DRAWING NO. D3394
TITLE LUG
REV. B
SHEET 1 OF 4
SCALE
NTS

DRAWING NO. D3394	TITLE LUG	REV. B	DART AEROSPACE LTD ENGINEERING ORDER		D.E.O. NO. D3394-B-1	SHEET NO. SHEET 1 OF 1	SCALE NTS
DRAWN AJS	CHECKED	MFG. APPR.	APPROVED		DE APPR.		
DATE 09.11.04	DATE 09.11.04	DATE 09.11.04	DATE 09.11.04		DATE 09.11.04

DRAWING NO. D3394	TITLE LUG	REV. B	DART AEROSPACE USA, INC ENGINEERING ORDER		D.E.O. NO. D3394-B-2	SHEET NO. SHEET 1 OF 1	SCALE NTS
DRAWN <i>gp</i>	CHECKED <i>Sc</i>	MFG. APPR. <i>M</i>	APPROVED <i>MP</i>		DE APPR. <i>MP</i>		
DATE 11.05.02	DATE 11.05.09	DATE 11.05.09	DATE 11.05.08		DATE 11.05.09

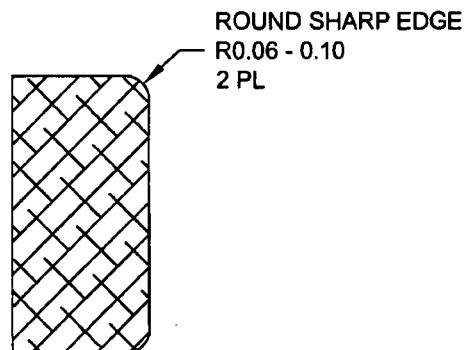
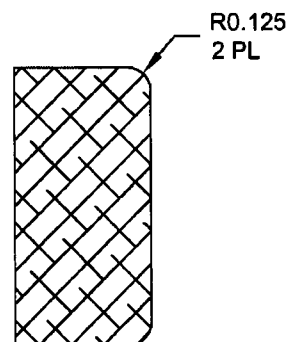
SHEET 4 ZONE A,1 MODIFY SECTION A-A AS SHOWN:

REASON: DRAFTING ERROR

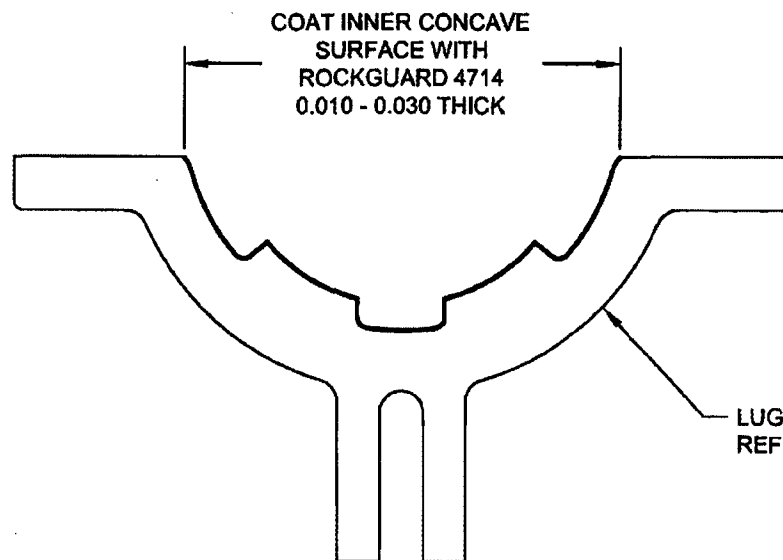
ADD D3394-xRG OPTION

D3394-xRG MOUNTING LUGS ARE INDENTICAL TO D3394-x MOUNTING LUGS, HOWEVER AFTER FINISH, COAT INNER CONCAVE SURFACE WITH "PLUS ONE ROCKGUARD 4714" AS SHOWN BELOW.

D3394-1RG LUG (SHOWN)
D3394-3RG/-5RG LUGS (SIMILAR)
D3394-041RG/-043RG/-045RG LUG ASSEMBLIES (SIMILAR)
